Access Compliance Report

Public Rights-of-Way (Curb Ramps)

Intersection ID: 52688	Main Street: CITY_PARK_DR	Cross Street: ARBOR_LOOP_DR	Location: SW
ADA ID: 7291B4A3B6ED	Ramp Type: Perp	Initial Pass/Fail: Fail	Overall Compliance: No
		Severity Score: 1.25

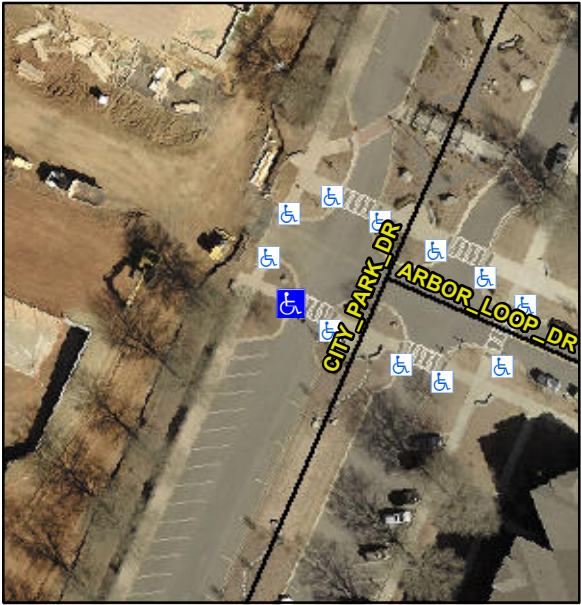
Codes/Mitigation Info/Possible Solution			Field Measurements/Component Compliance		
	Possible Solutions:		Compliance	Description	Data
	Remove & Replace Entire Ramp.		Yes	Ramp Length (in)	72.0
			N/A	Ramp Width (in)	70.0
			N/A	Flare Type LT	N/A
			N/A	Flare Slope LT (%)	N/A
			N/A	Flare Traversable LT?	N/A
			N/A	Flare Type RT	N/A
			N/A	Flare Slope RT (%)	N/A
			N/A	Flare Traversable RT?	N/A
			N/A	DWS Provided?	N/A
<p>Surveyor Notes:</p> <p>N/A</p>			N/A	DWS Contrast?	N/A
			N/A	DWS Length (in)	N/A
			N/A	DWS Full Width?	N/A
			N/A	DWS Offset (in)	N/A
			N/A	Gutter Ponding?	N/A
			N/A	Gutter X Slope (%)	N/A
			N/A	Painted X Walk1?	Yes
			N/A	X Walk 1 Direction	To SE
			N/A	X Walk 1 Width (in)	112.0
			N/A	X Walk 1 Slope (%)	2.8
<p>PROW/ADA:</p> <p>R304.5.3</p>			N/A	X Walk 1 X Slope (%)	4.5
			N/A	Ramp inside XWalk1?	Yes
			N/A	Road Slope (%)	N/A
			N/A	Road X Slope (%)	N/A
			N/A	Any Obstructions?	N/A
			N/A	Obstruction Type

N/A	Clear Space?	N/A
			N/A	Clear Space to XWalk (in)	N/A
			N/A	Storm Grate/Utility Hazard?	N/A
			N/A	Storm Grate/Utility Type	
<p>Total Cost:</p> <p>\$ 1850.00</p>			N/A	Surface Condition? (G/P)	Good
